Land to the south of HSDC, Waterloooville

Stage 1 Road Safety Audit : Designer's Response

Project No.	1017
Revision	Initial Issue
Date	21 st March 2022
Client	Places for People
Prepared	B Fenton
Checked	C Grindle
Authorised	A Wozniczko
File Ref.	P:\1017 South Downs College\C Documents\Reports\RSA Designer's Response

FIGURE**2.1**

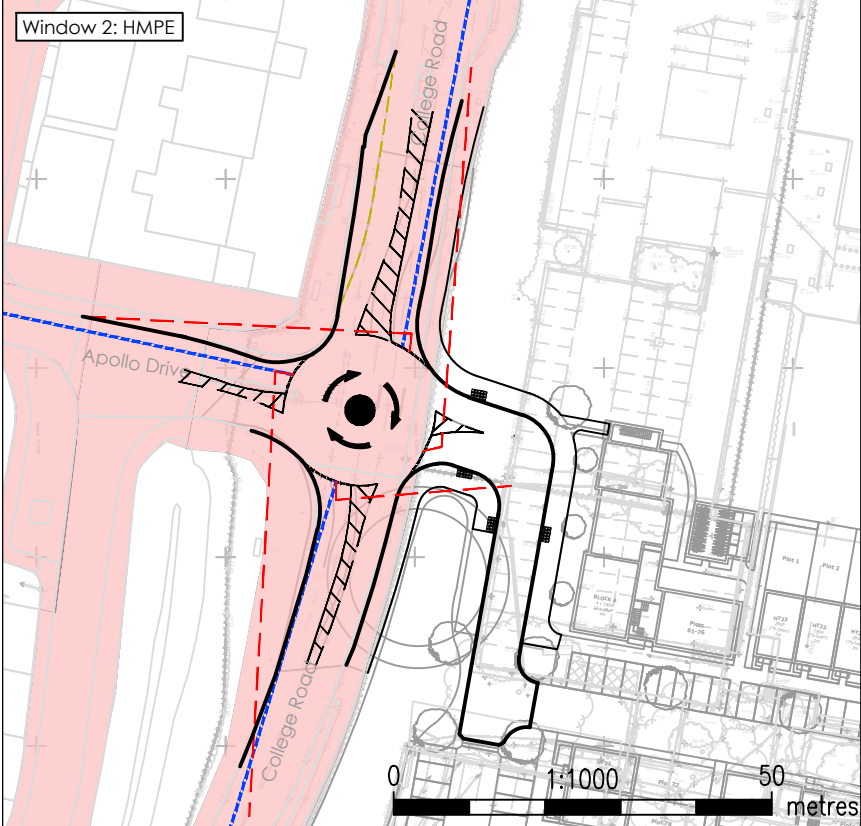
Whilst the Audit team note the content of the Pre-Application Scoping Note – (Access & Transport) with regard to traffic capacity at the proposed new four arm mini roundabout they remain concerned that when considering the proposed new traffic signal junction at the nearby Camptown development immediately southwest of the proposed mini roundabout that this could result in significant traffic congestion. In particular, four arm mini roundabouts will have four crossovers giving significant opportunity for collisions to take place during a busy peak hour period. Additionally, mini roundabouts are of particular concern to riders of two wheeled vehicles who are over represented in collisions at mini roundabouts and normal roundabouts alike.

If the four-arm mini roundabout option proceeds then the Audit team would recommend that the design as presented is revisited to look at the potential for two lane approaches in order to separate ahead and right turning traffic. Additionally, if feasible a separate access to the development should be provided for cyclists and pedestrians.

ARCADY analysis has been undertaken under very robust conditions which demonstrates that the greatest estimated queue on the southern arm of the proposed mini-roundabout would be one vehicle in the 2027 Baseline + Development scenario. A summary of the ARCADY results is seen below in Table 2.1, and included in full at Appendix C. The traffic flows upon which ARCADY analysis is based are included as Appendix within Appendix A as Figure 2.1.

- 2.1 The mini-roundabout is expected to operate well within capacity in the 2027 Baseline + Development scenario, with a maximum RFC value of 0.39 found on the College Road (N) arm of the roundabout during the PM Peak.

PROJECT:			SOUTH DOWNS COLLEGE		
TITLE:					
PRELIMINARY HIGHWAY LAYOUT					
PROJECT No:		DRAWING No:		REV:	
1017		PHL-101		C	
SCALE @ A3:					
AS SHOWN

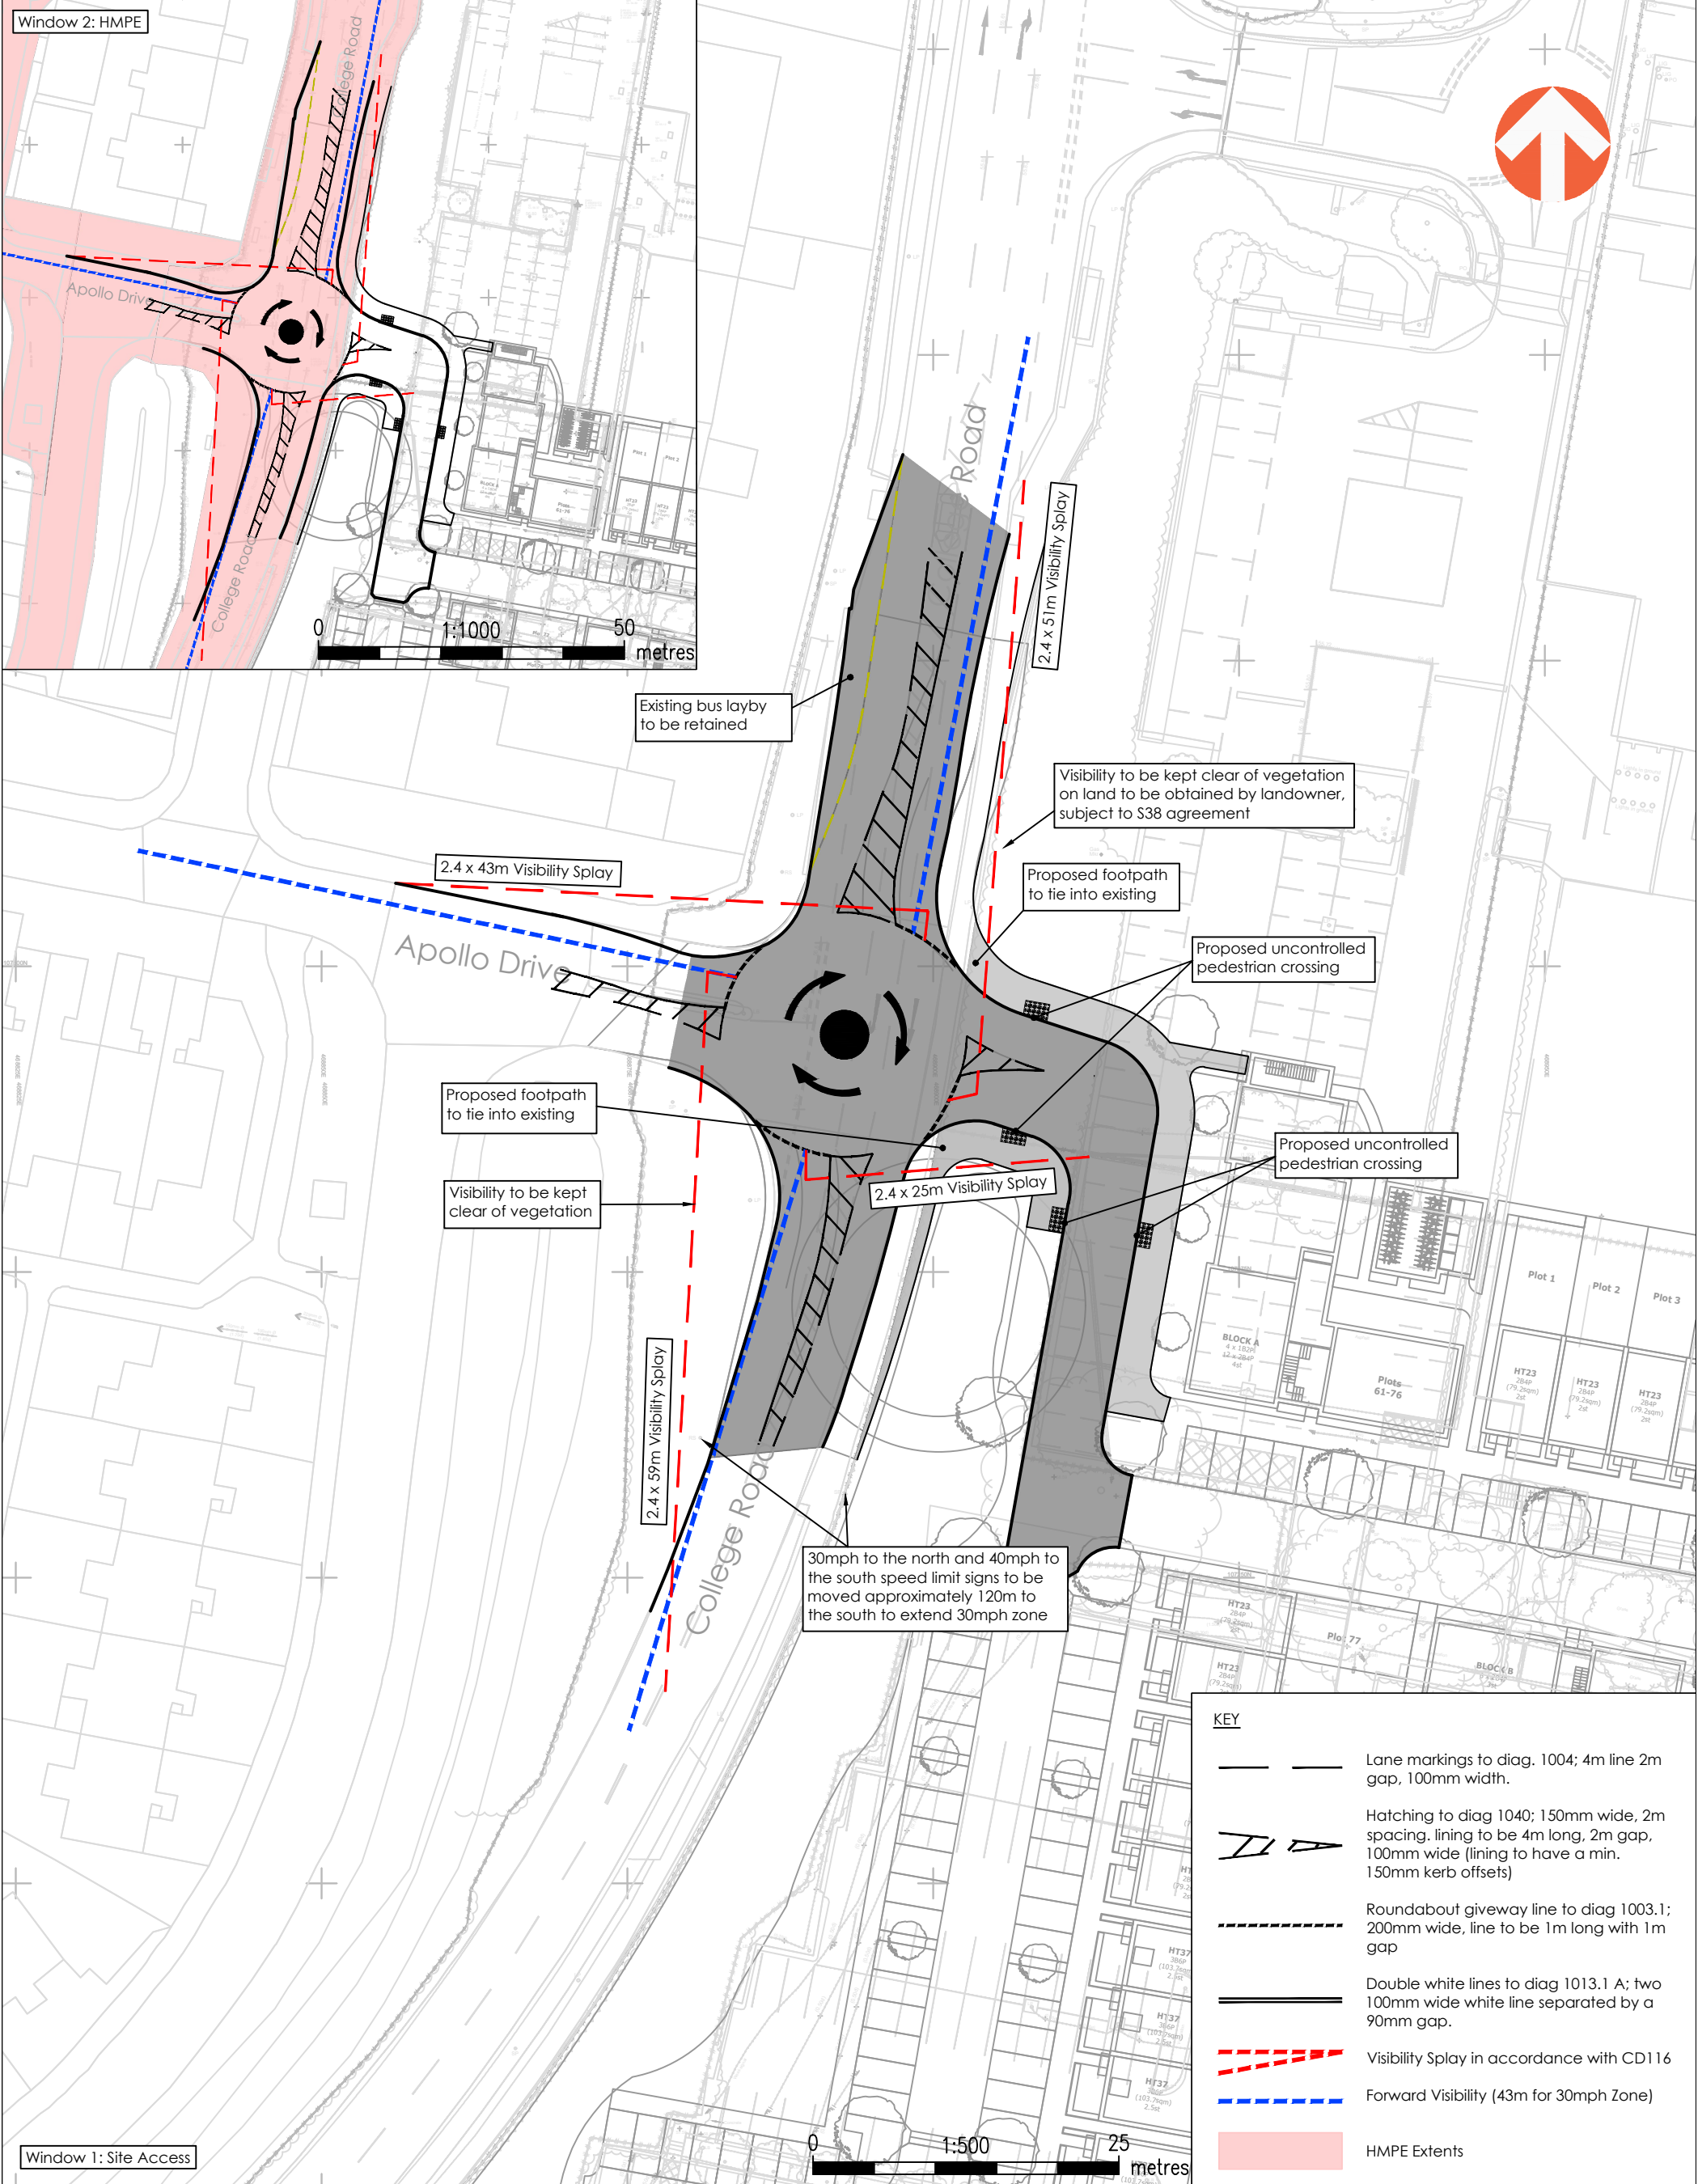
The Audit team are concerned that the proposed four arm mini roundabout design lacks adequate entry deflection, particularly on the northeast and southwest approaches on College Road. Inadequate entry deflection on the approach to a mini roundabout could lead to an inappropriate approach speeds, overshoots and side impact type collisions.

Notwithstanding recommendation 3.1 above the design as presented should be revisited to allow for adequate entry deflection on all approaches to the mini roundabout, but in particular for those on College Road.

The Audit team are concerned that the drawing provided for the proposed four arm mini roundabout does not provide for the swept path analysis of the largest vehicle likely to need to negotiate the junction from all arms. Insufficient road space for the largest vehicle required to negotiate the proposed new mini roundabout junction could lead to sideswipe type collisions, injudicious reversing, shunts and the potential for over running of the footway and collisions with pedestrians and passing cyclists.

The design of the proposed four arm mini roundabout should provide for sufficient road space to accommodate the largest vehicle required to use the junction from all directions.

It is not clear from the drawing what if any facilities for pedestrians will be provided to cross College Road and Apollo Drive at the proposed new four arm mini roundabout junction. Inadequate facilities for pedestrians to cross College Road and Apollo Drive to and from the new development could lead to potential slips and trips, particularly involving pedestrians with visual or physical impairments and parents with buggies.

The proposed four arm mini roundabout junction should provide adequate provision for crossing pedestrians.

Adequate entry deflection has been provided on the north- and southbound approaches. This has been achieved by moving the mini-roundabout towards the west and widening the splitter islands on each arm. This has provided at least 0.8m deflection on each arm in accordance with advice contained within DMRB CD-116.

Swept path analysis has been undertaken which demonstrates that a 16.5m articulated lorry can pass through the junction between the College Road arms without encroaching onto the footway or opposite carriageway, nor the central roundel, included as drawing 1017-01-ATR-103 in Appendix A. Swept path analysis has also demonstrated that the largest type of refuse vehicle can turn into and out of the site or Apollo Drive without encroaching on footways or the opposite carriageway. These are included as drawings 1017-01-ATR-102 and 1017-01-ATR-104 in Appendix A.

There is an existing pedestrian refuge approximately 30m to the north of the proposed access junction, which will remain in place, and drawing 1017-SK-101-B has been updated to provide uncontrolled crossing facilities for pedestrians on the site access arm.

- 3.1 It is concluded that the RSA raised no issues with the fundamental principle of providing a mini-roundabout in this location.
- 3.2 Drawing no. 1017-PHL-01-C contained in Appendix A shows an updated version of the Audit drawing that reflects the audit recommendations and scheme amendments set out in the Designer's Response summarised above.
